# **Taraborah Coal Project**

## **Response to Submissions on the Draft Environmental Impact Statement**

**RE: Response to Submissions on the Draft EIS for the Taraborah Coal Project**

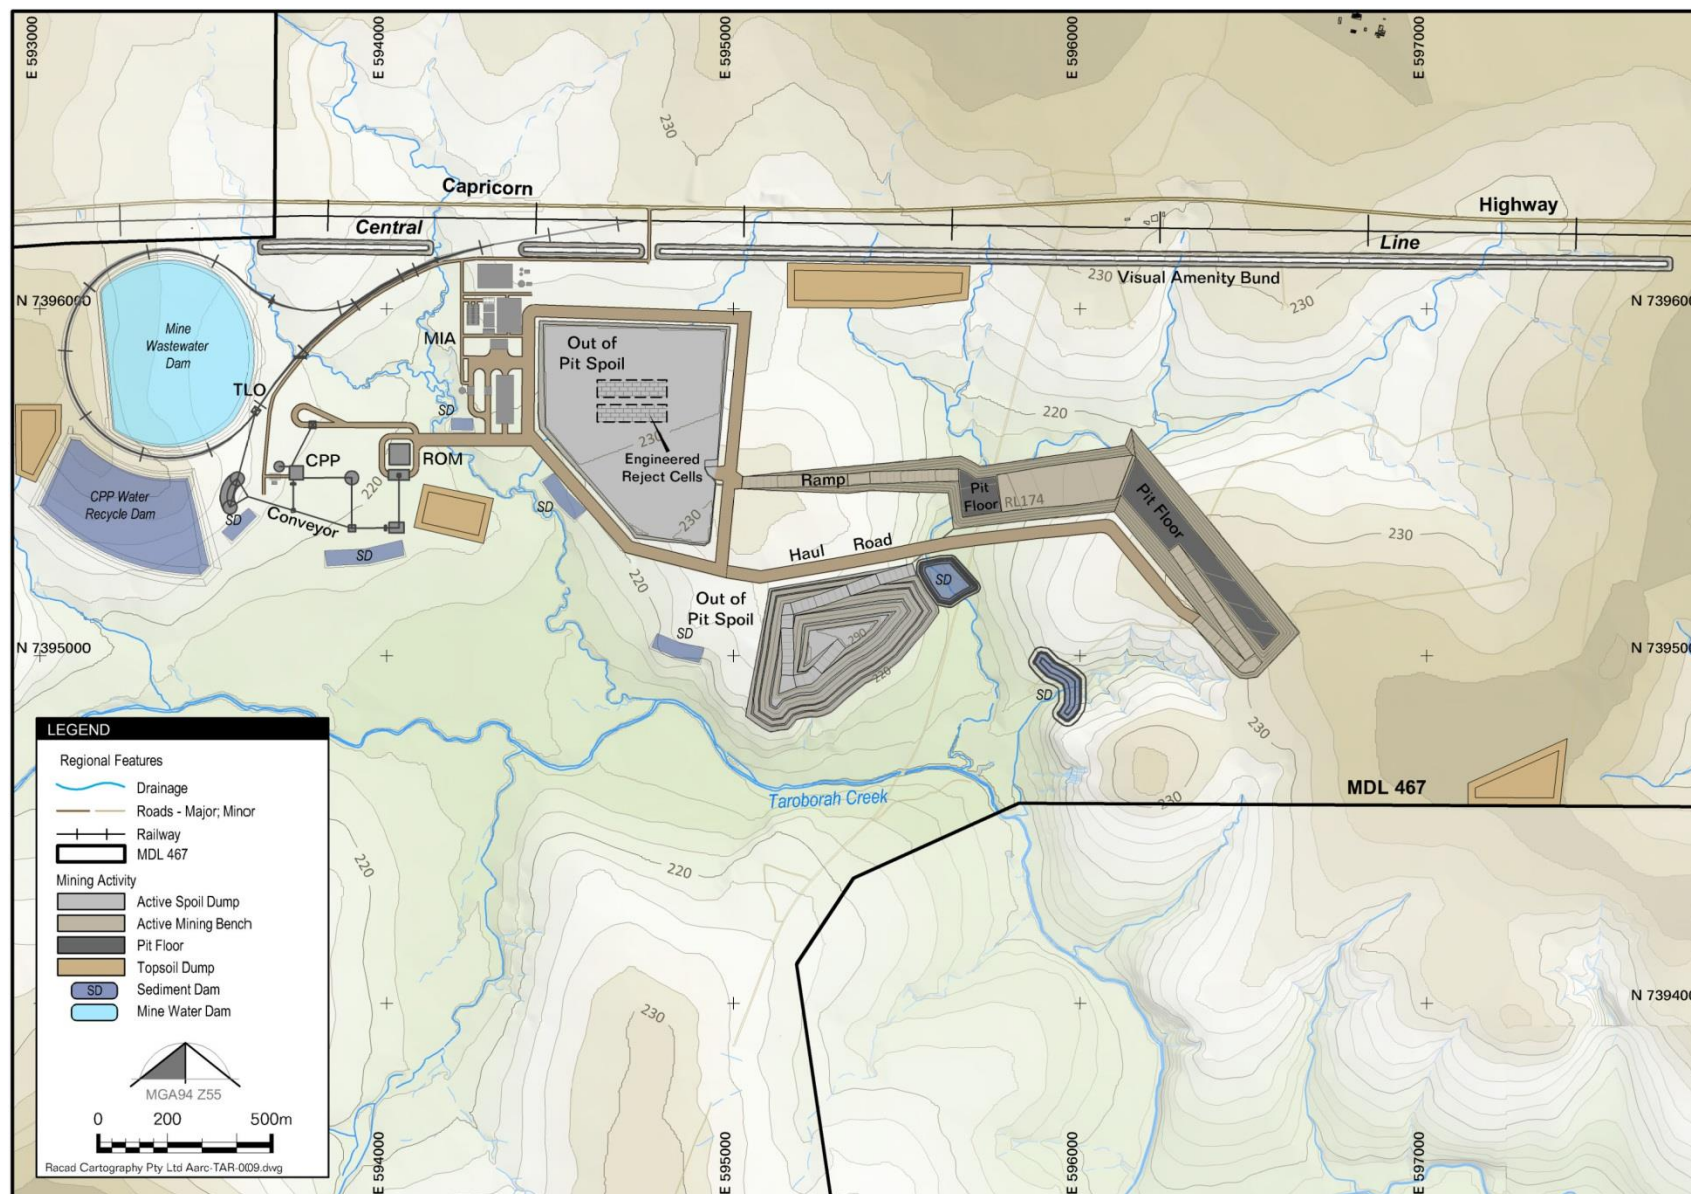
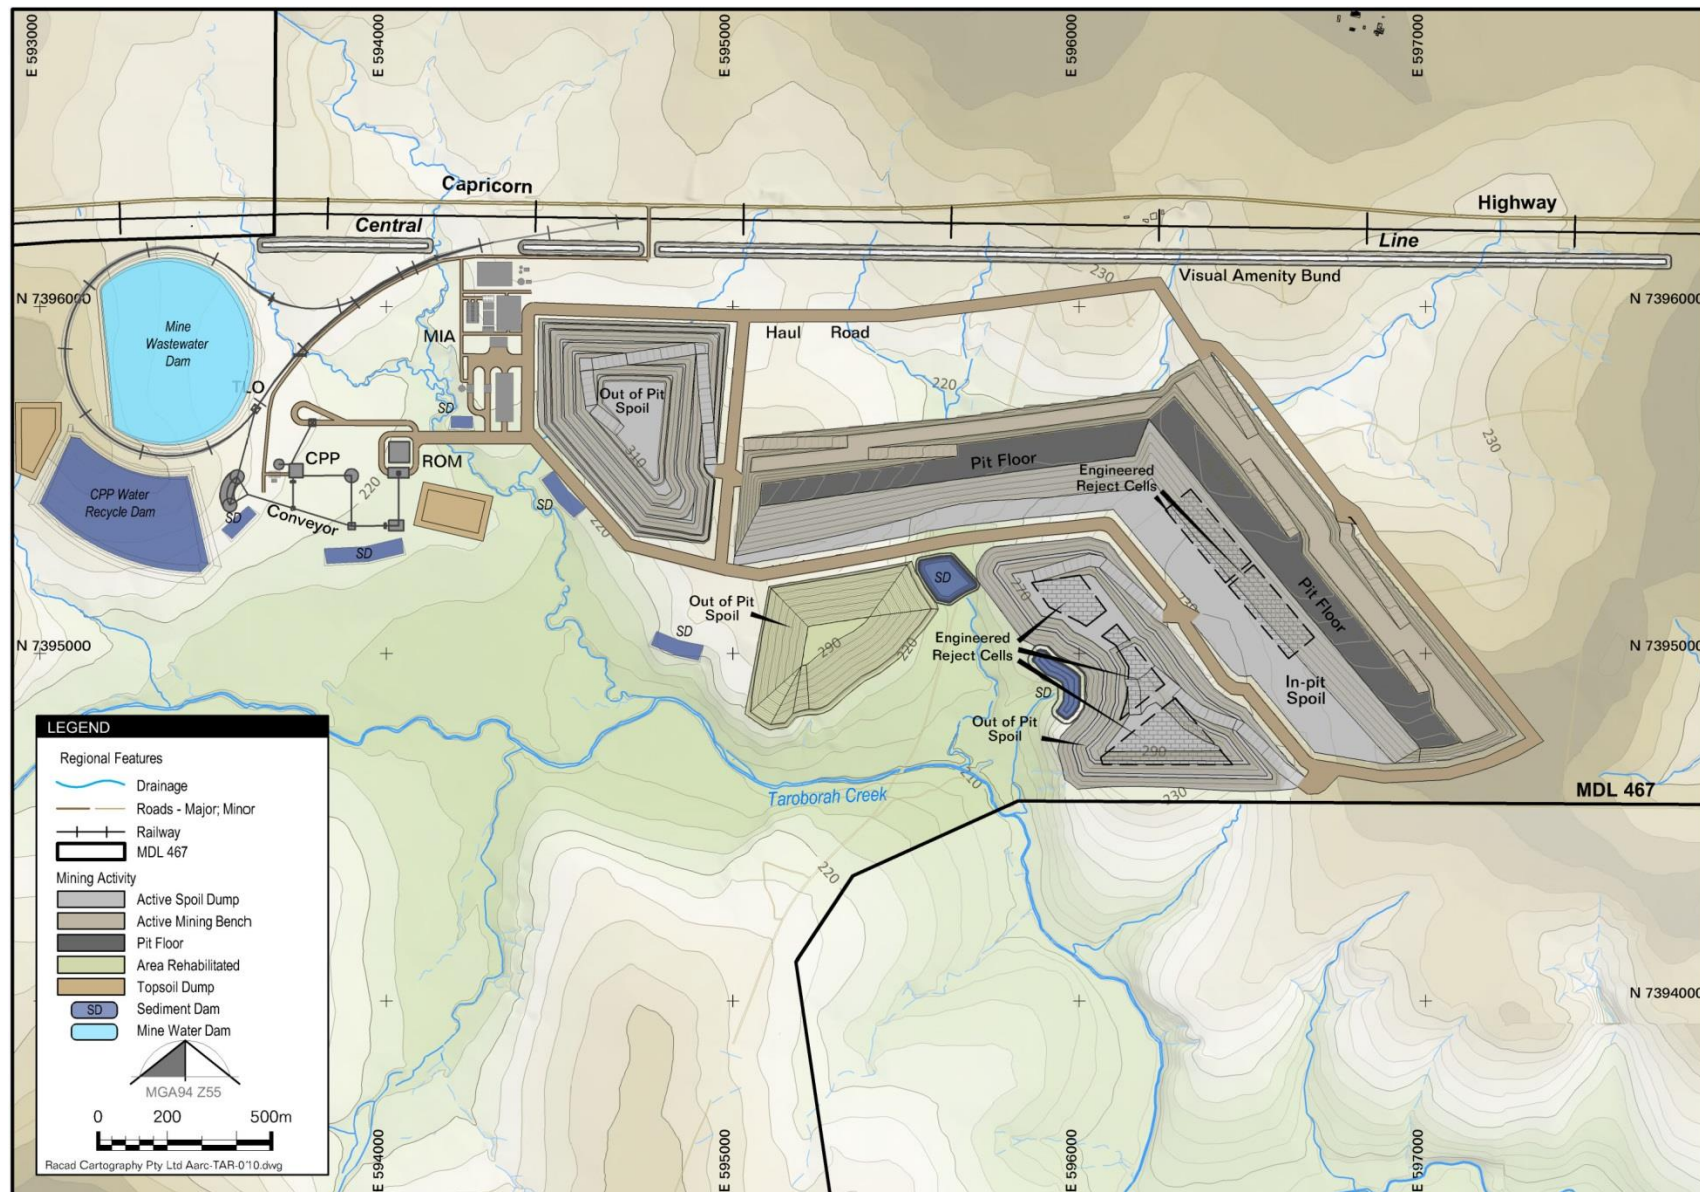
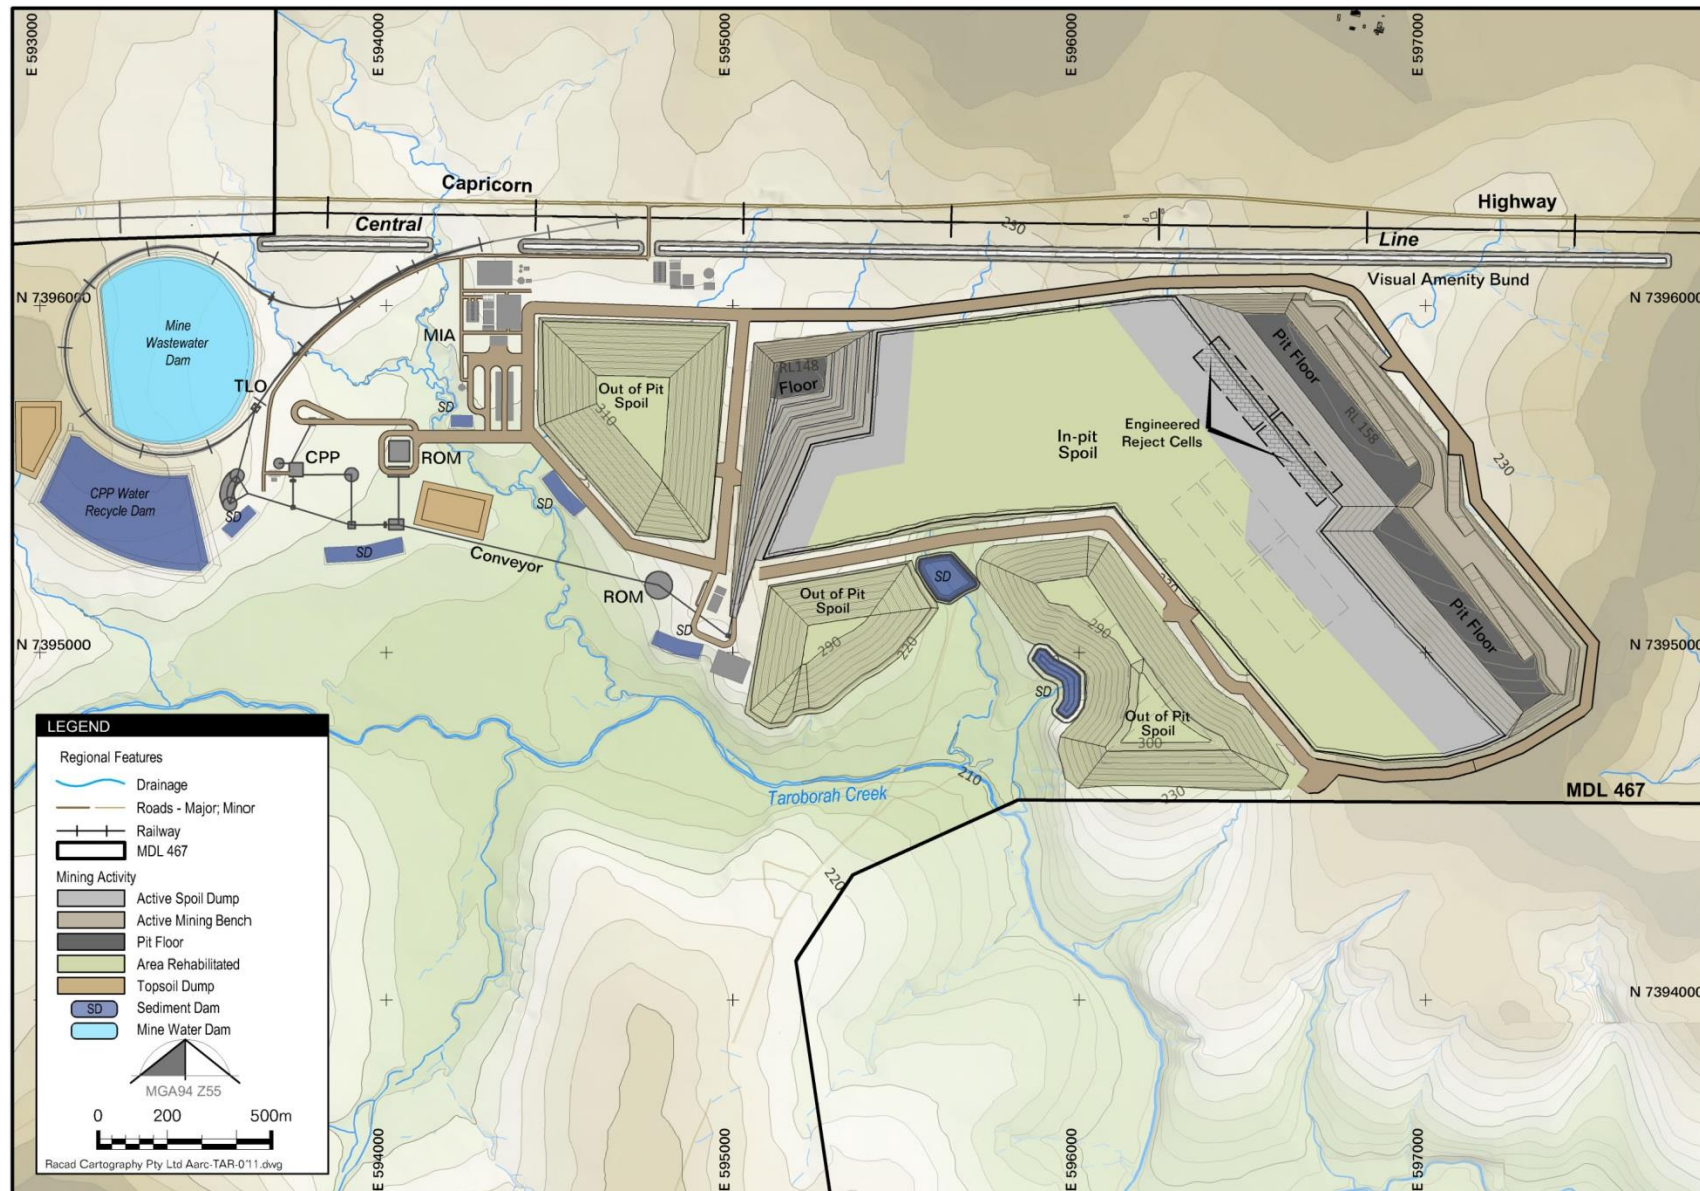
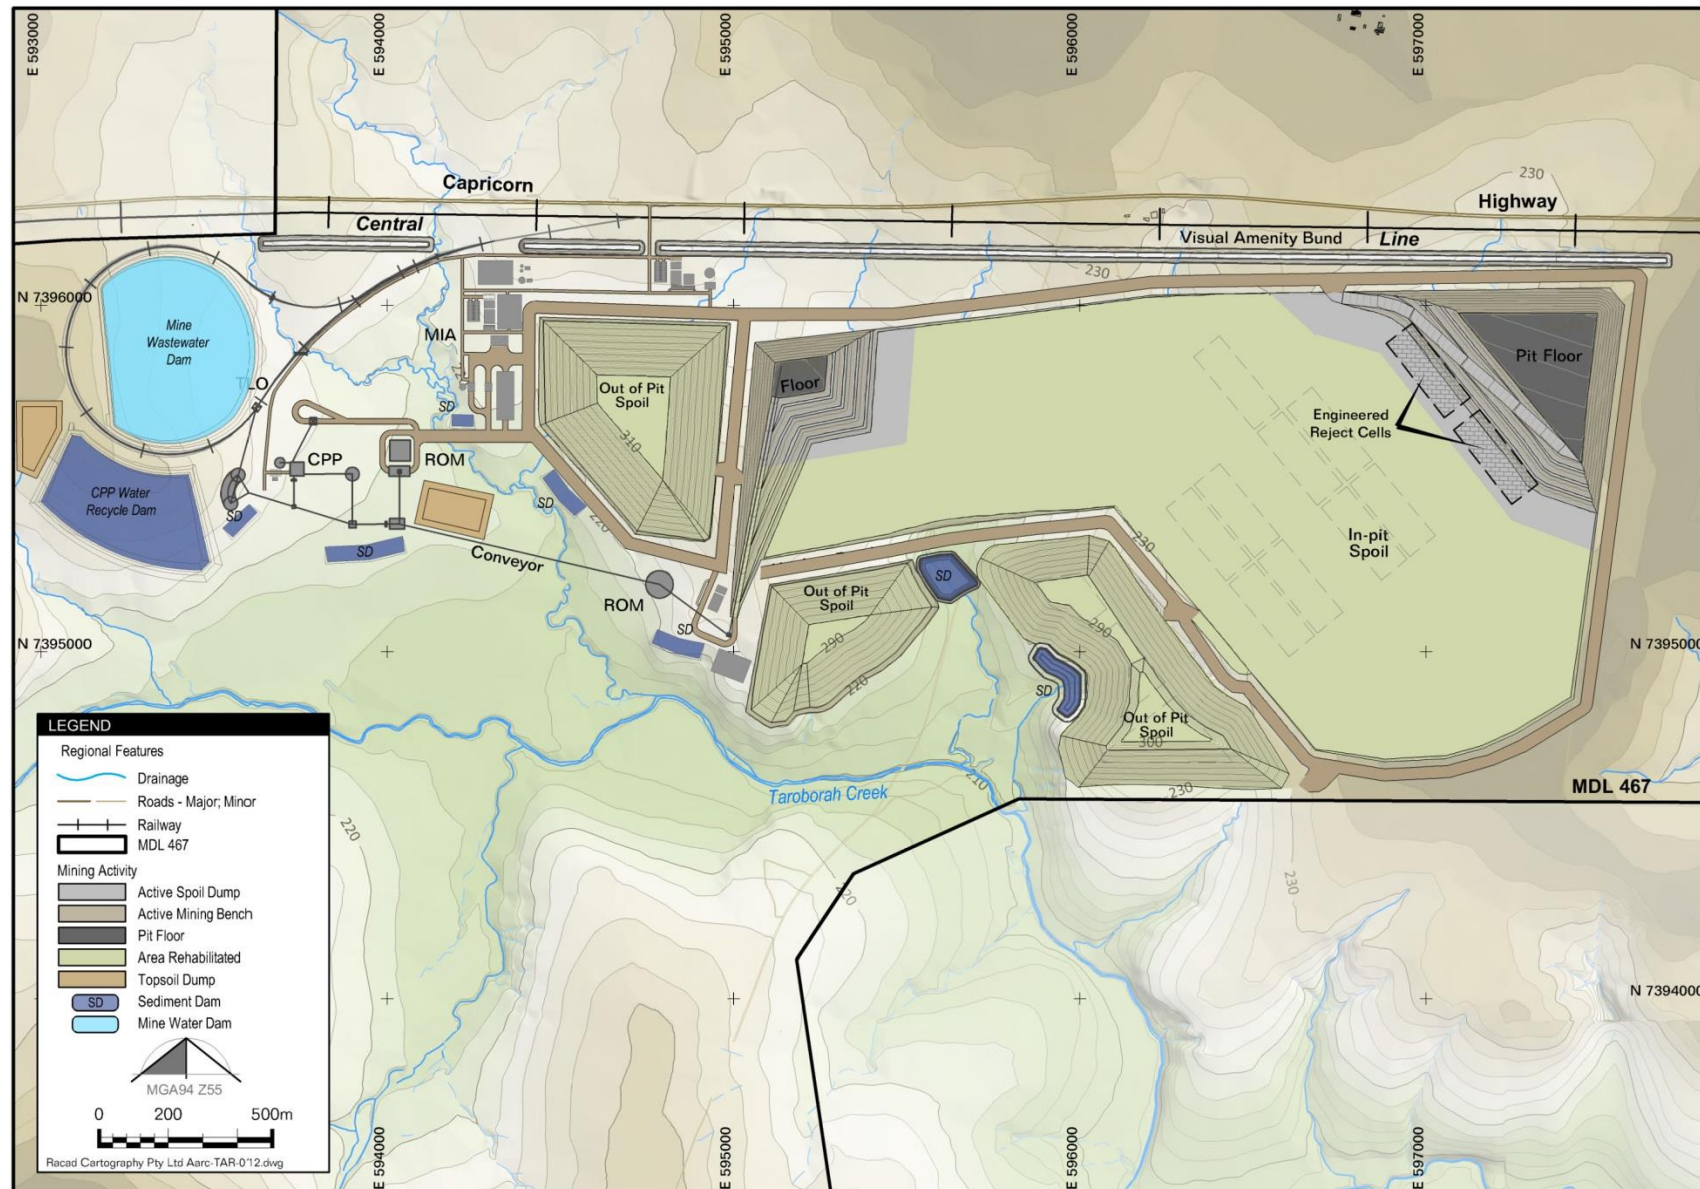
As stated several times in the rehabilitation section of the report, rehabilitation will be completed as soon as practical, with rehab of the out-of-pit spoil dumps commencing in Year 2 and complete by Year 4, and the in-pit spoil rehab progressing once the final lift of waste is placed. This progression is more fully illustrated in the amended Figures 3.17 – 3.20 that are reproduced below and will replace the previous versions in the final EIS document.

As mentioned, the above Table 3.37 has been added to Section 3.7.7.1 of the final EIS document. And the following amended Figures 3.17 – 3.20 replace the previous versions in the final EIS document.

**Figure 4.122 Infrastructure Buffer Zone (50 m)**

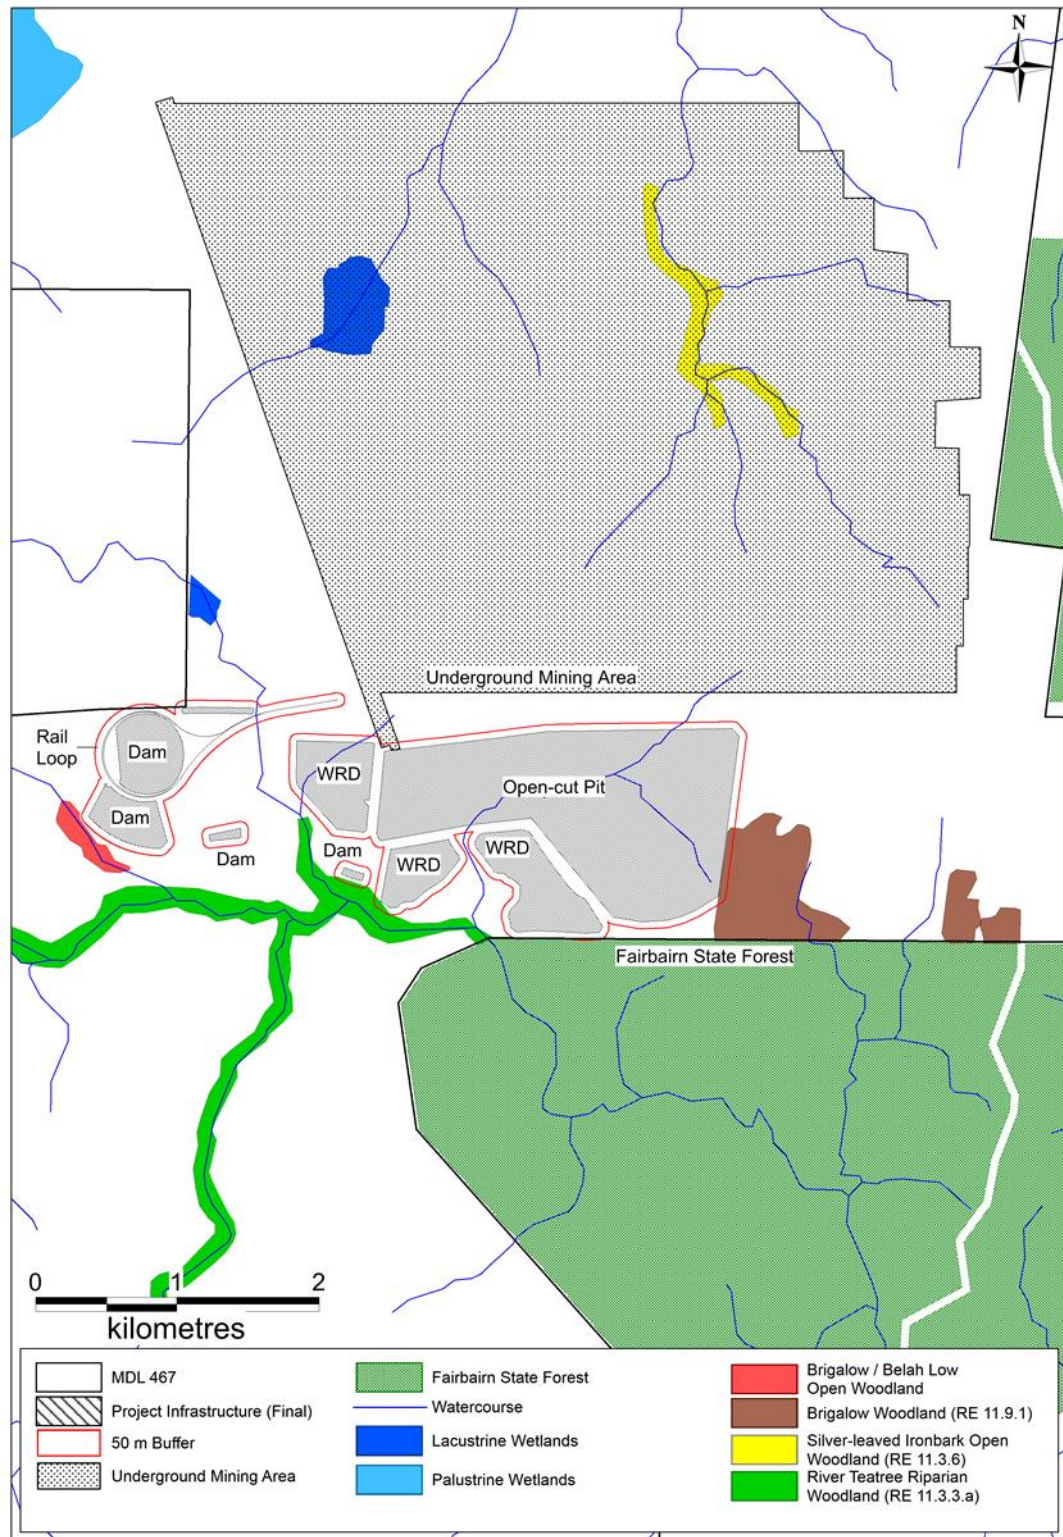
- “Project disturbances will be progressively rehabilitated on completion of work. Where possible, a 50m buffer zone has been implemented around sensitive aquatic ecosystems as illustrated in Figure 4.122; and”

And the following figure has been added as Figure 4.126 in Section 4.8.3.3.
